Charlotte-Mecklenburg Planning Department

SUBJECT: Administrative Approval for Petition No. 1989-096 The Flad Mullinax Partnership

PROJECT NAME: U.S. FOODS - EASTWAY EXPANSION

U.S. FOODS

STAKING AND MATERIALS PLAN

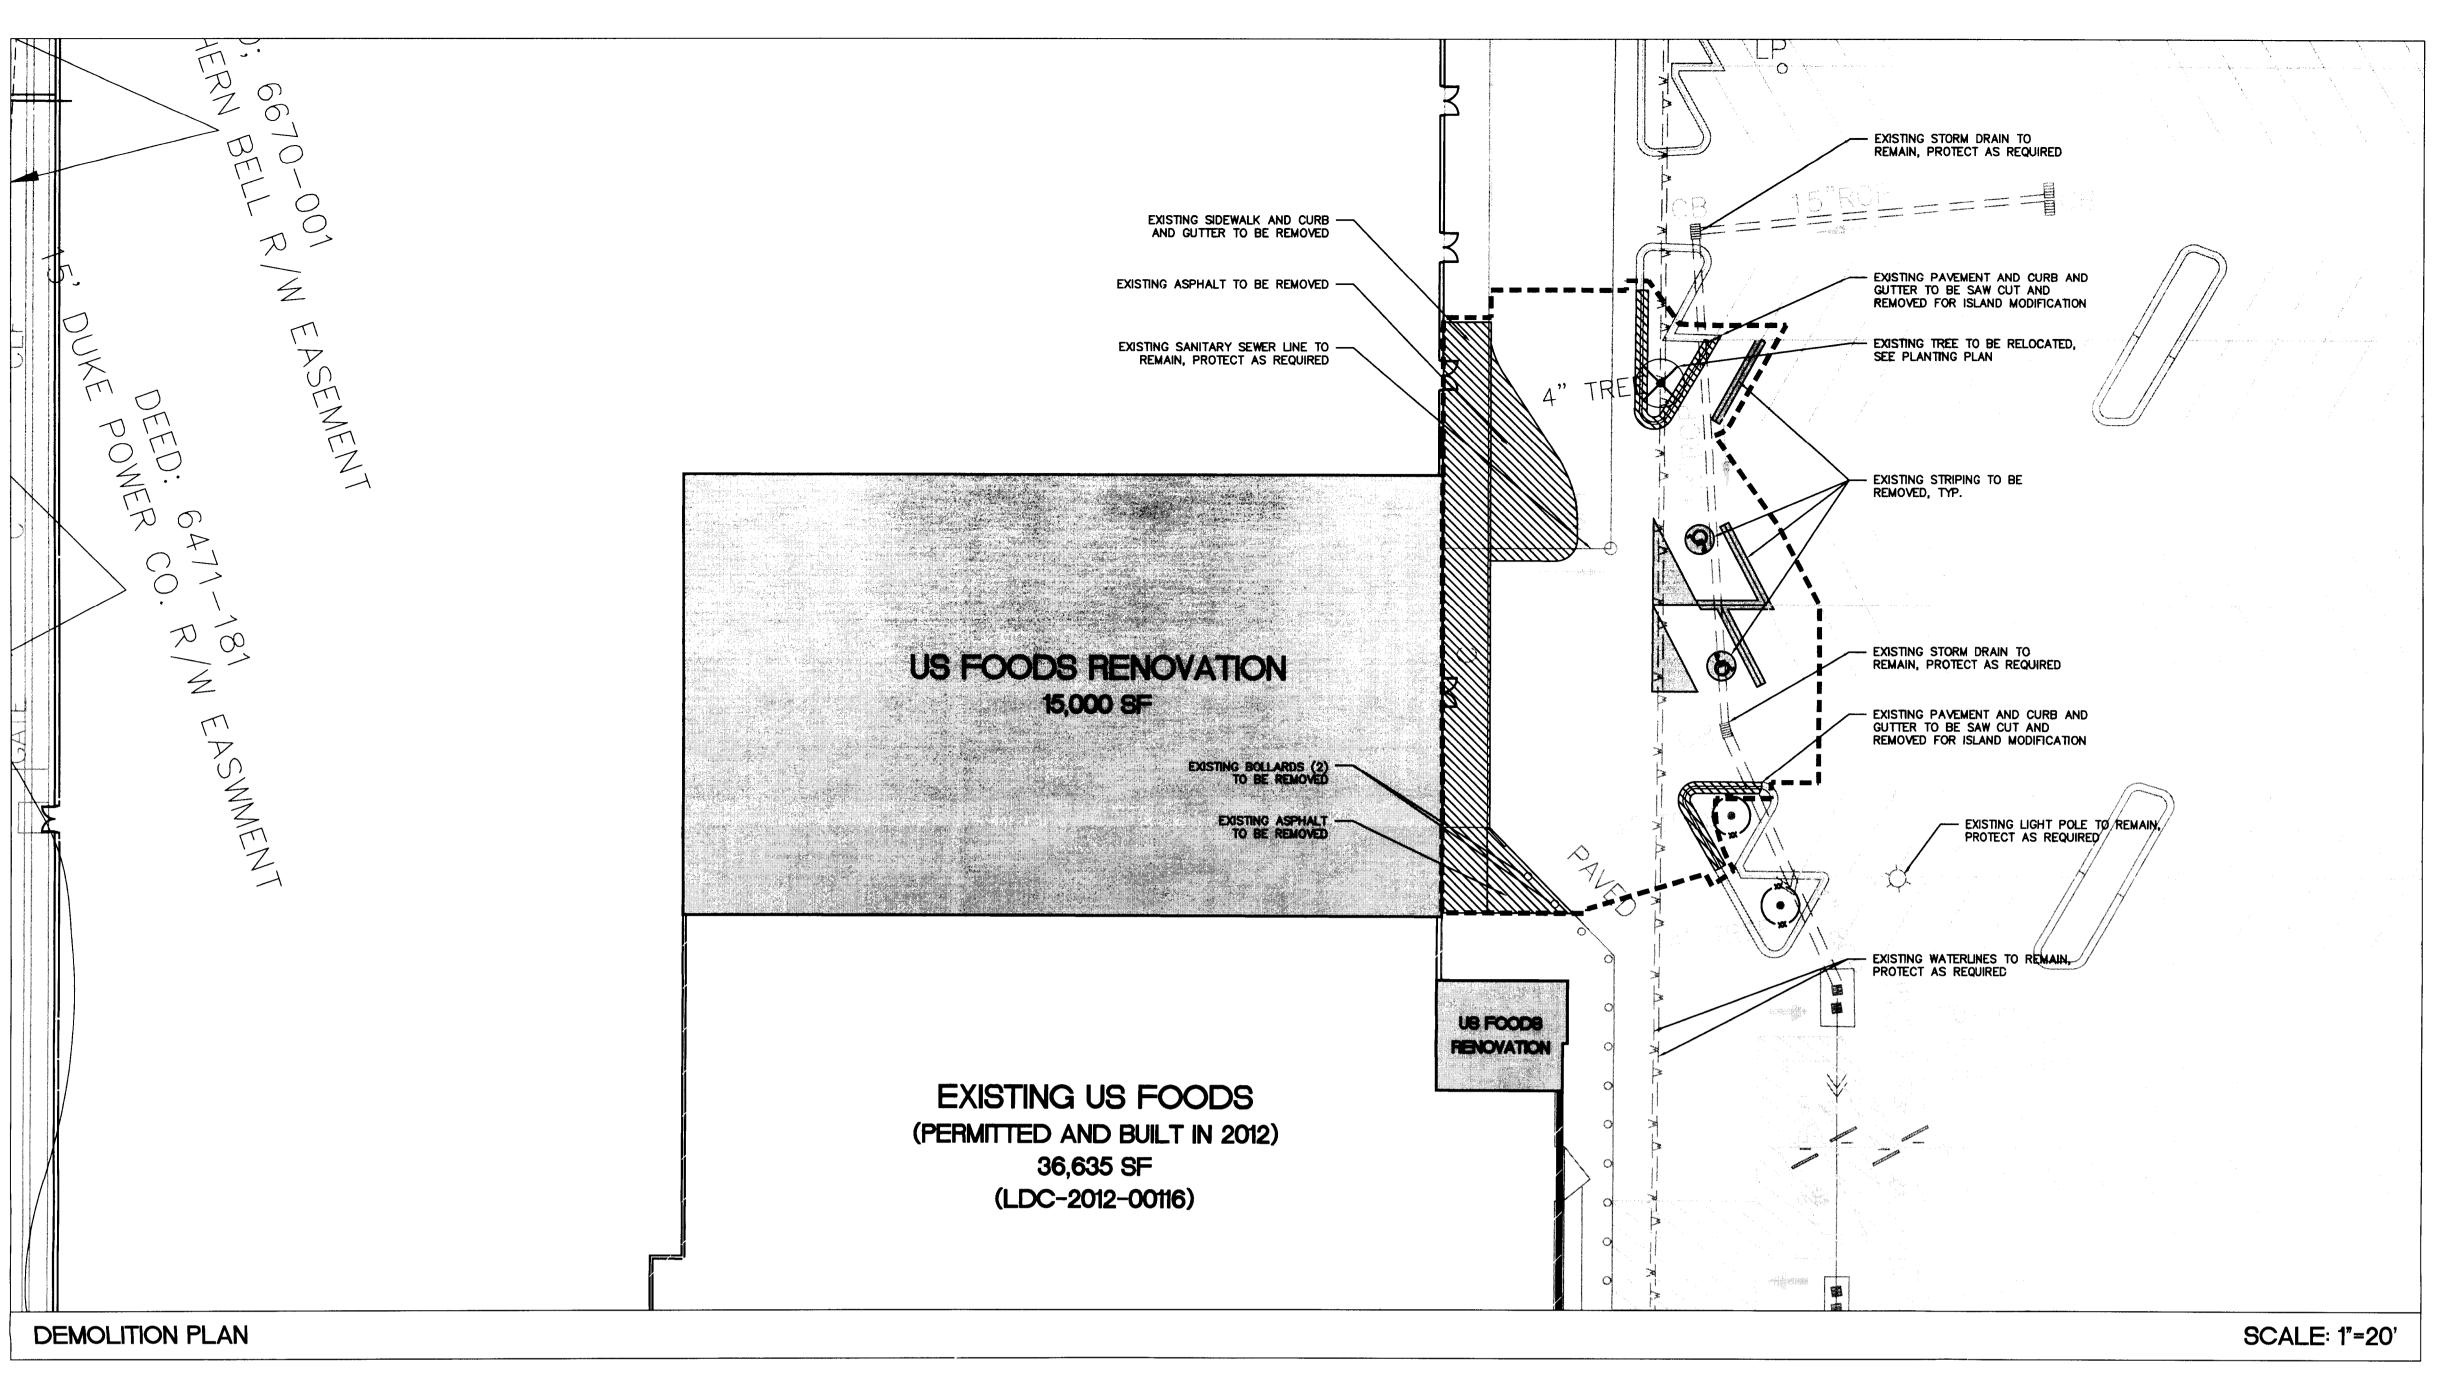
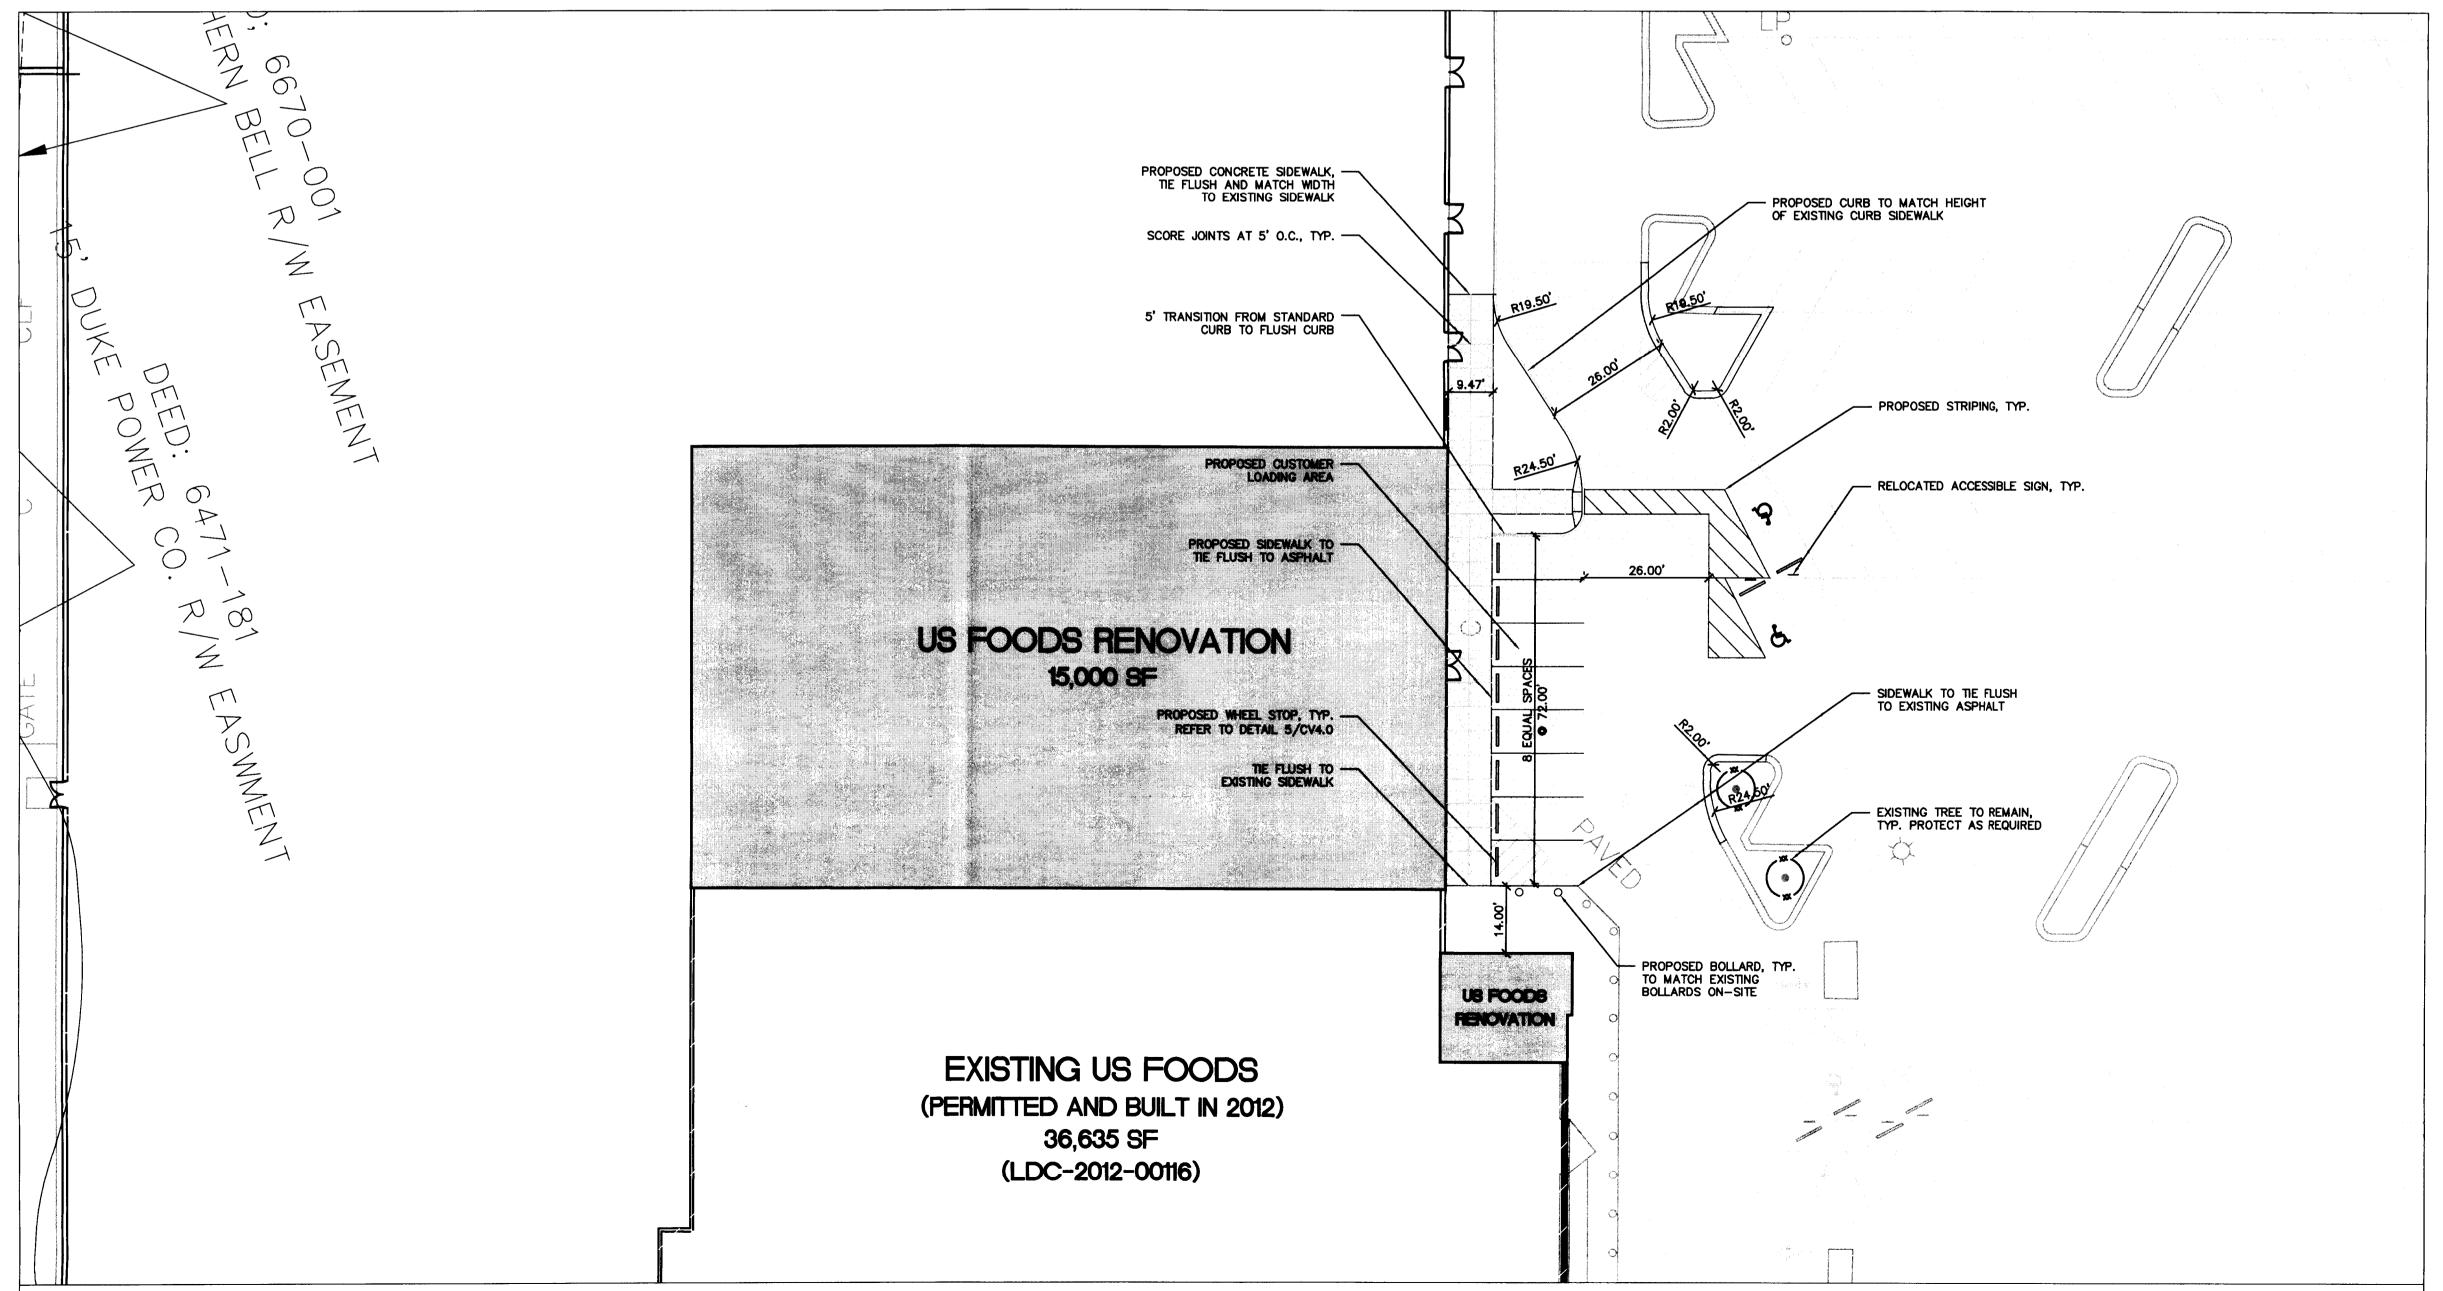
August 21, 2013 TO: Mark Fowler Debra Campbell Zoning Supervisor Planning Director SUBJECT: Administrative Approval for Petition No. 1989-096 The Flad Mullinax Partnership Attached are revised site plans and elevations for the 15,000 square foot expansion of the US

Foods. The plans have been revised to show an expansion and a loading at the front of the store. Since these changes do not alter the intent of the development and meet the requirements of the conditional site plan, I am approving these plans. Please use these plans when evaluating requests for building permits and certificates of occupancy.
